Subdivision#2024-00003
635 Upland Place

Application	General Data	
Request: Public hearing and consideration of a request for a subdivision with variations to re-subdivide an existing lot into two lots.	Planning Commission Hearing:	June 4, 2024
	Approved Plat must be Recorded By:	December 4, 2025
Address: 635 Upland Place	Zone:	R-5/Residential
Applicant: Windmill Hill LLC represented by M. Catharine Puskar, attorney	Small Area Plan:	Taylor Run/Duke Street

SUBJECT: DOCKET ITEM #8 – SUB #2024-00003 – 635 UPLAND PLACE

Figure 4 – Wetland and required buffer area

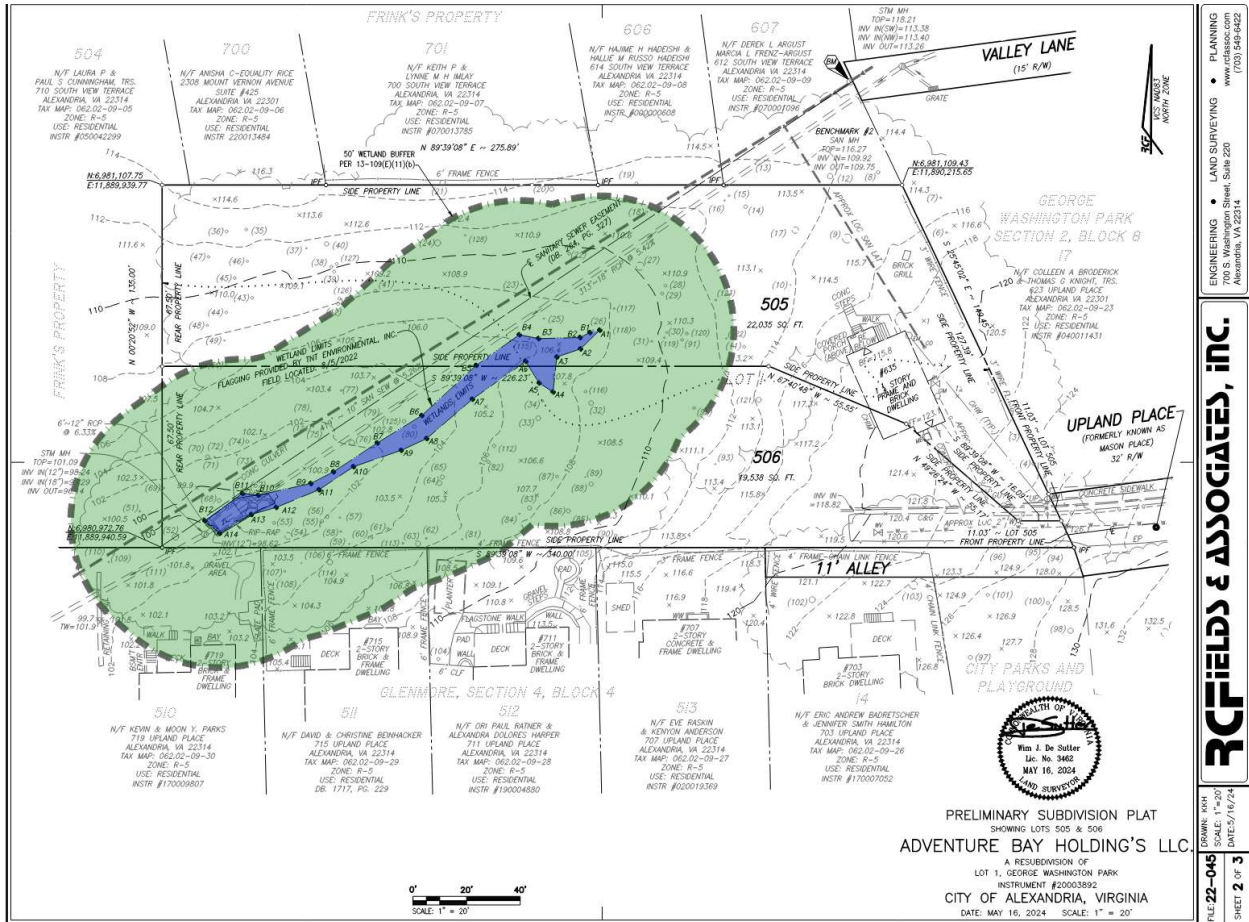
An isolated wetland shown in blue in Figure 4, below, occupies the subject property’s western half. Zoning Ordinance section 13-109(E)(11) requires both protection of this feature from direct stormwater runoff and preservation of its water quality functions. To meet this requirement, a 50-foot vegetated buffer must be established and maintained. The buffer area is shown in green in Figure 4, below, occupies approximately 20,546 square feet (49 percent) of the subject property. Section 13-109(E)(11) severely limits development of any kind within the wetland buffer. Generally, these provisions only allow conservation/preservation measures and passive recreational activities.

Figure 6 – Proposed Lots (lot 505 in green, lot 506 in blue)

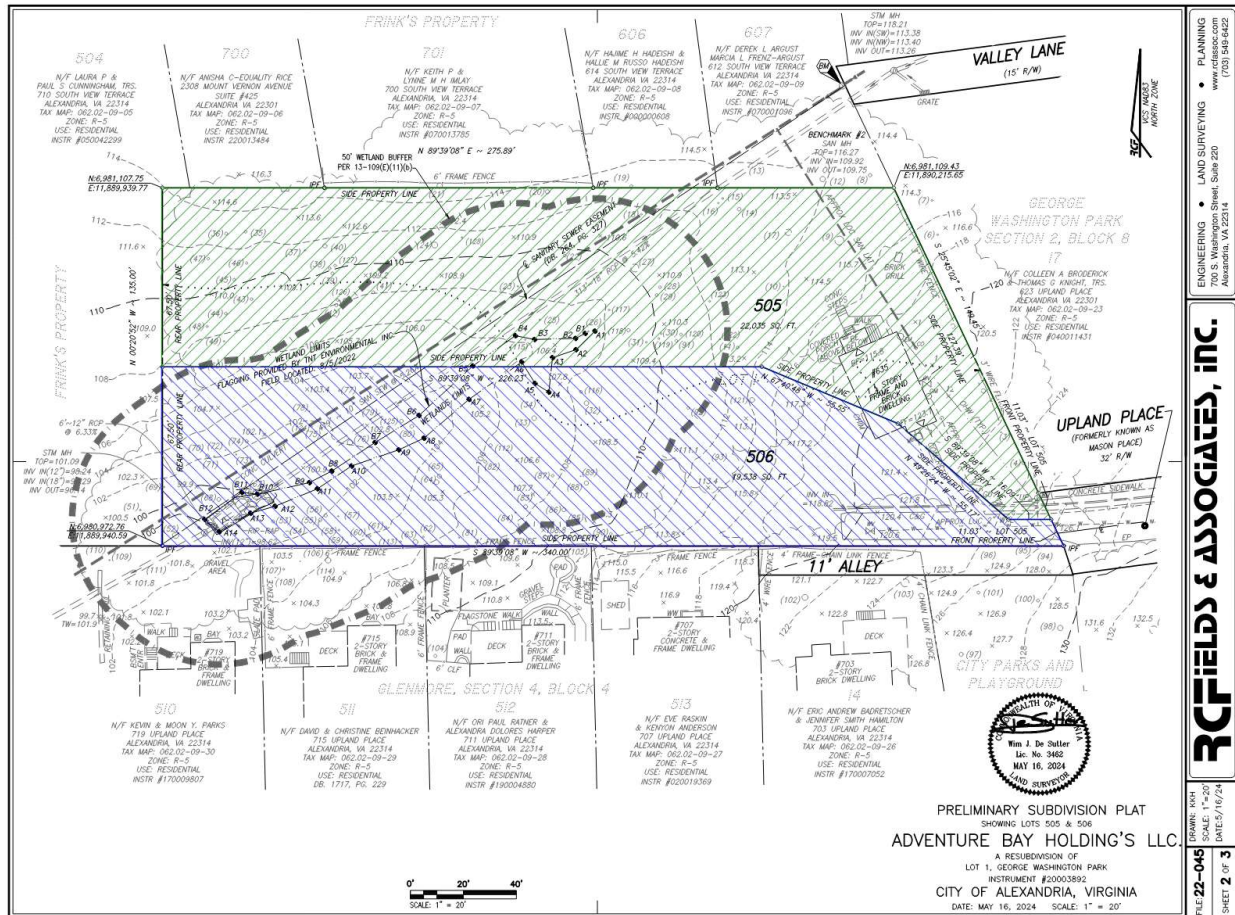
The subject property is zoned R-5/Residential. The proposed lots would not meet the R-5 zone’s 40-foot frontage requirement as the existing property has only 22.06 feet of frontage on Upland Place. The proposed lots would not meet the R-5 zone’s minimum width requirement either. The proposed configuration, which creates insufficient lot widths, is necessary for both lots to provide frontage on Upland Place.

Minimum lot width requirements ensure that lots are wide enough to accommodate buildings and provide appropriate setbacks. The proposed lots would taper significantly toward their front lot lines. These shapes are necessary for each lot to have access to the existing substandard street frontage. Although the proposed lots would not meet the technical lot width requirement, the general land use purpose of the lot width requirement would be upheld. Each lot would provide more than 50 feet of lot width at the proposed building site which would exceed the minimum lot

EXHIBIT C

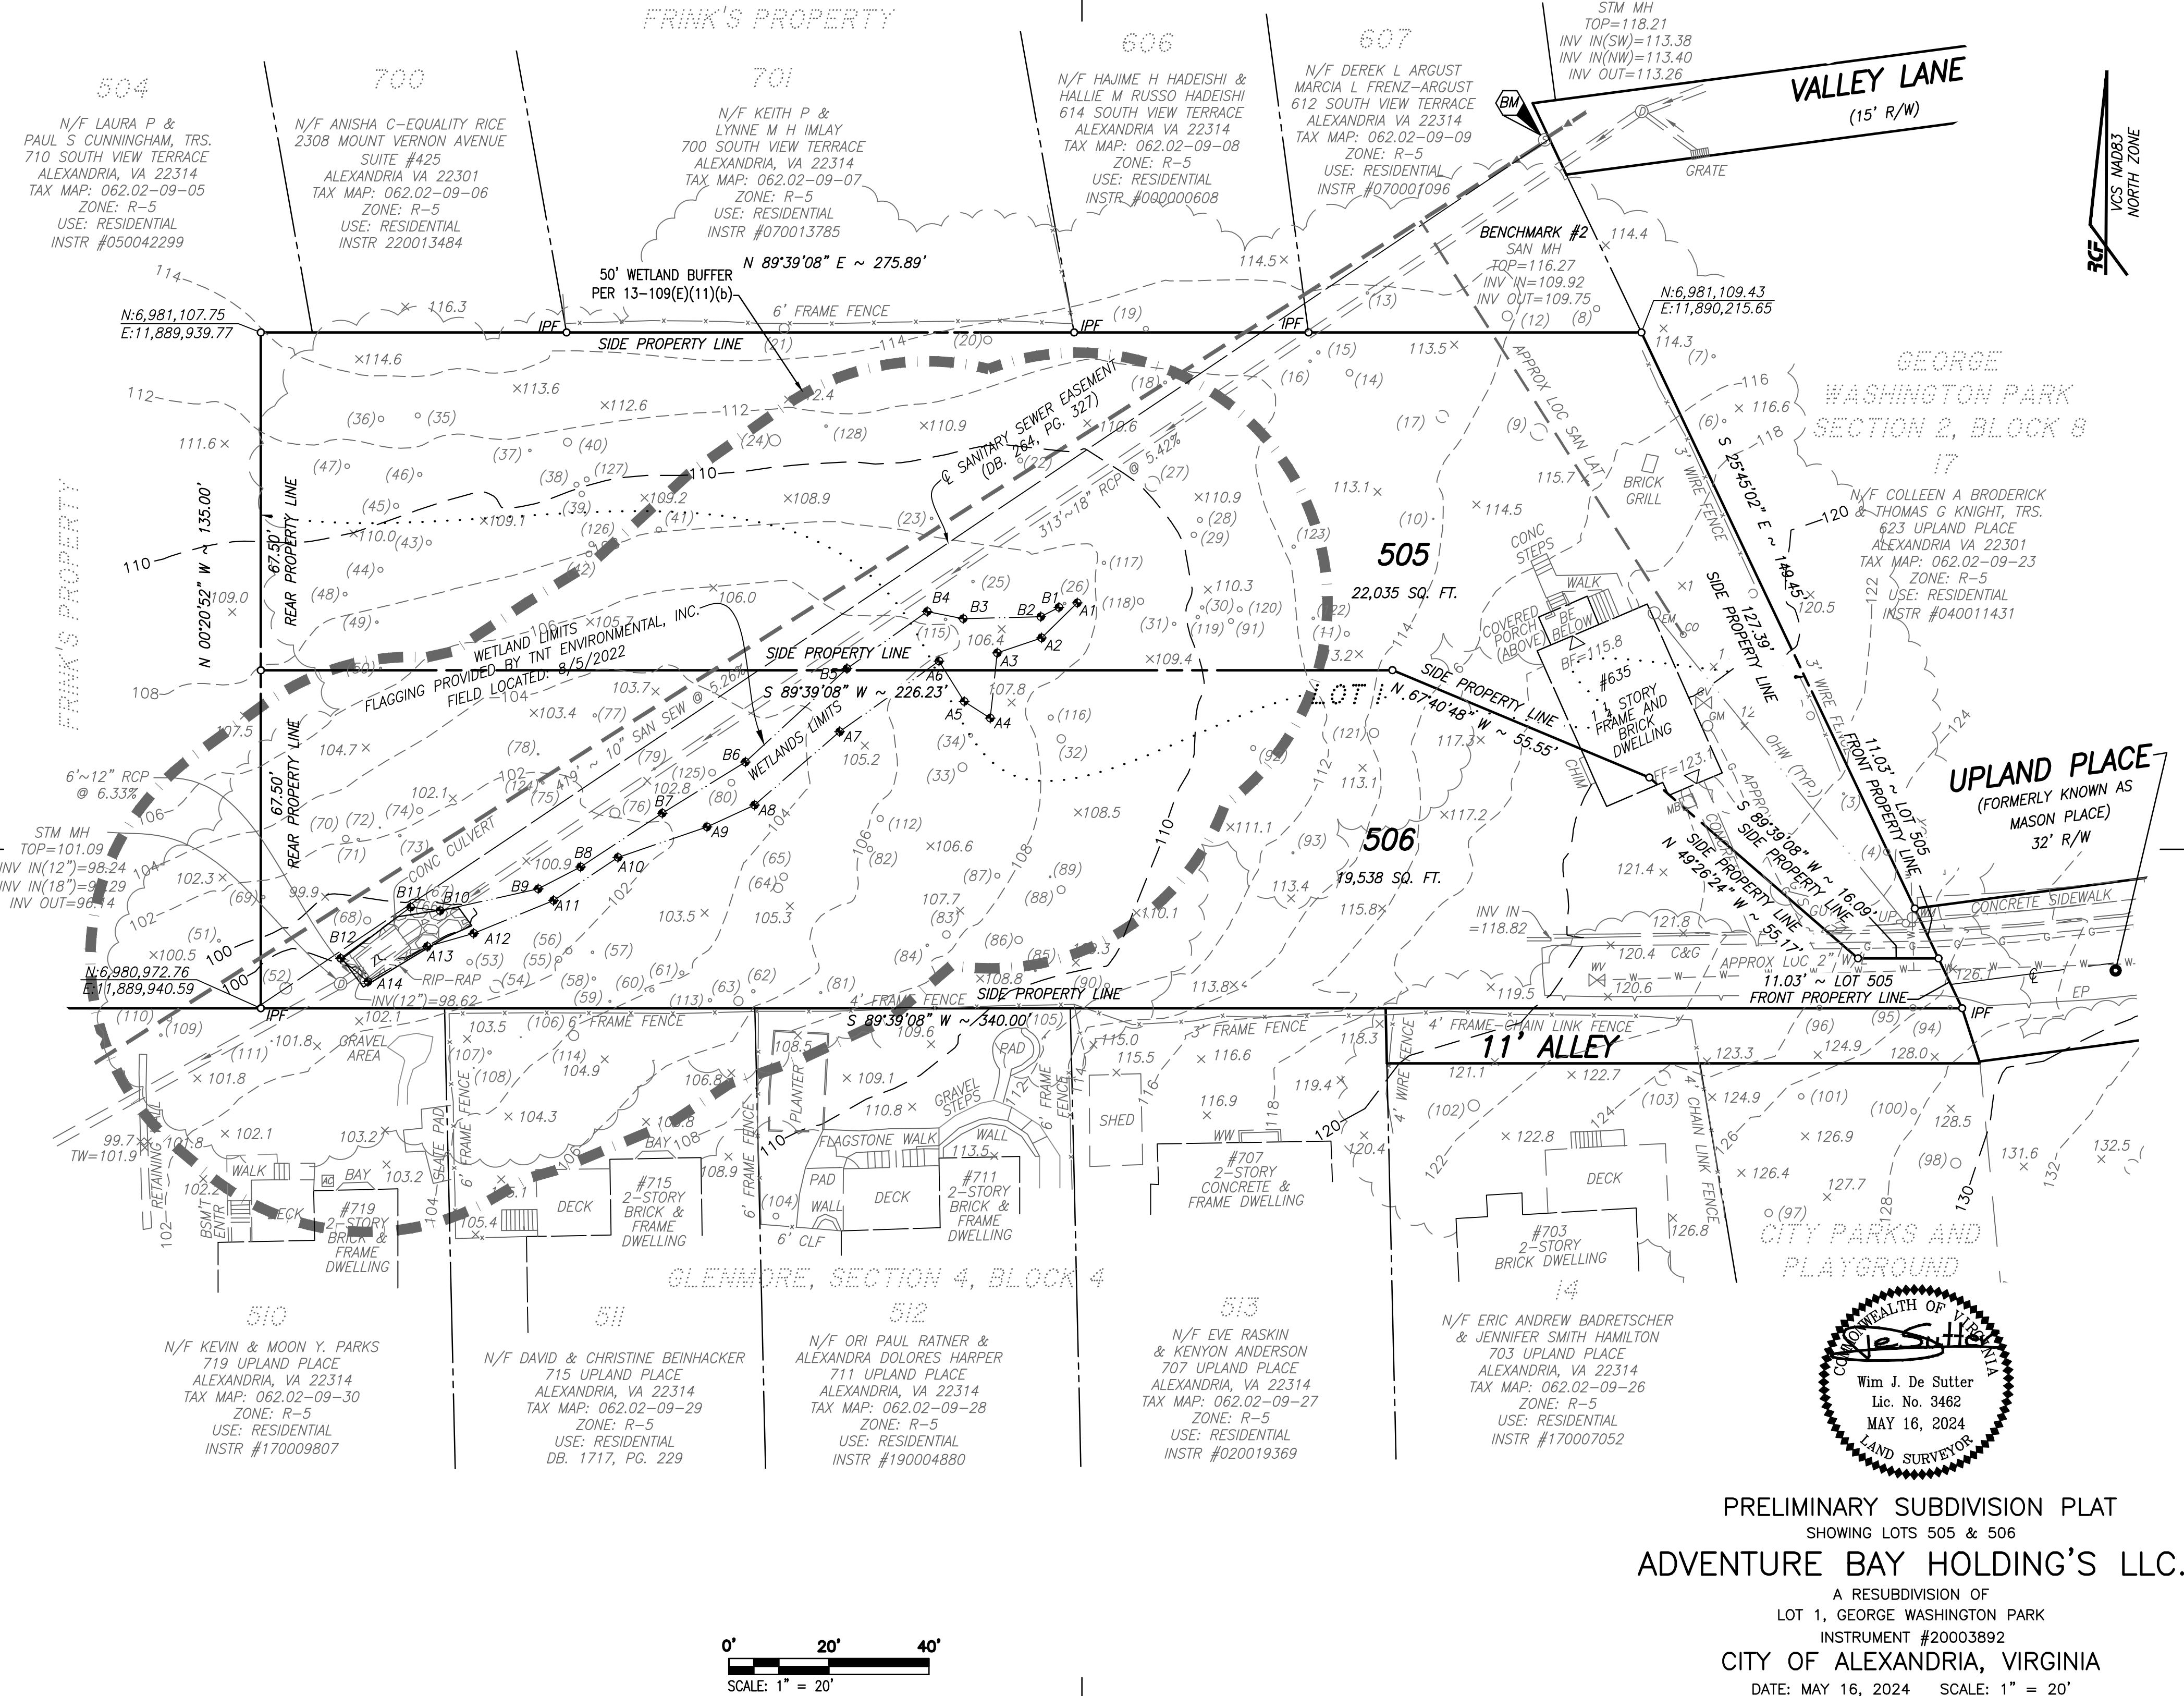
R-1 The applicant shall install “no parking” signs on both sides of Upland Place in the area shown on Exhibit C submitted May 21, 2024 to the satisfaction of the Chief Fire Marshall. (Fire)

The application appears to ask (in the accompanying Conceptual Layout) that the city establish a no-parking zone on the stub end of Upland Place, apparently to protect the applicant’s street frontage and access. It is interesting that this requested no-parking zone extends along nearly the entire street frontage of 623 Upland Place, the adjoining parcel on Upland. The applicant seeks to force its neighbors to give up the street parking in front of their own house so that the applicant can build two houses on its own land. Unsurprisingly, it offers no account of what the neighbors think of this proposal, or what will happen whenever they—or the residents of the proposed houses—host a party.

branches off of Upland Place to its dead-end at the subject property. Because the roadway narrows, no-parking zones need to be established to ensure adequate access for emergency services. Regardless of subdivision approval, this area should not be used for on-street parking as it could inhibit access to the subject property.

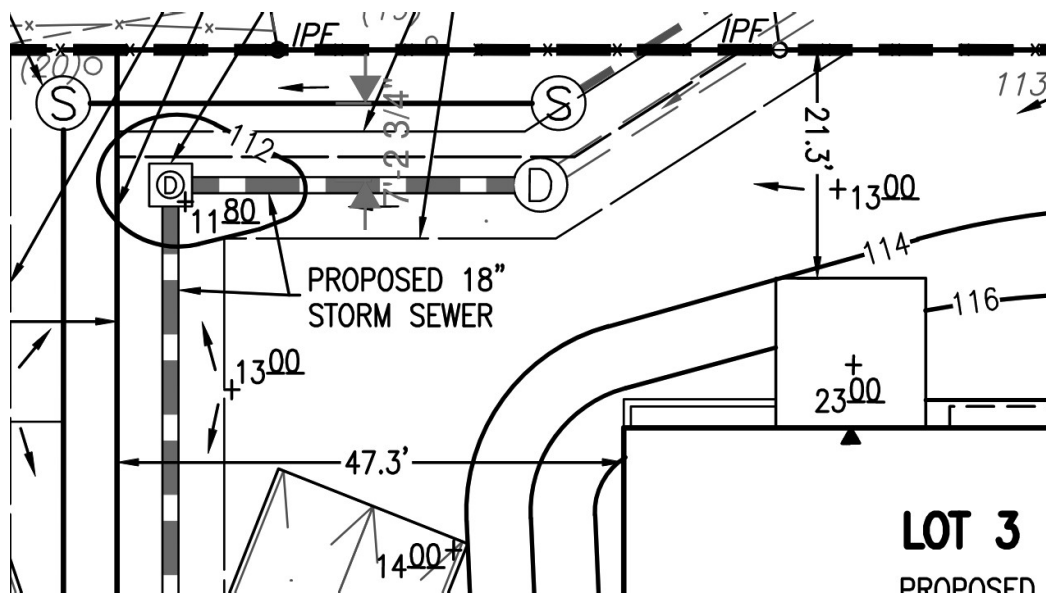
22. On sheet 4, there is only one “No Parking” sign which is not enough to prevent cars from parking along the cul-de-sac. Provide more signage to enforce the restriction. (Traffic Engineering)
23. Provide a completed curb with a crosswalk at the end of the spur back across to the main sidewalk on Upland Place like shown below. (Transportation Planning)
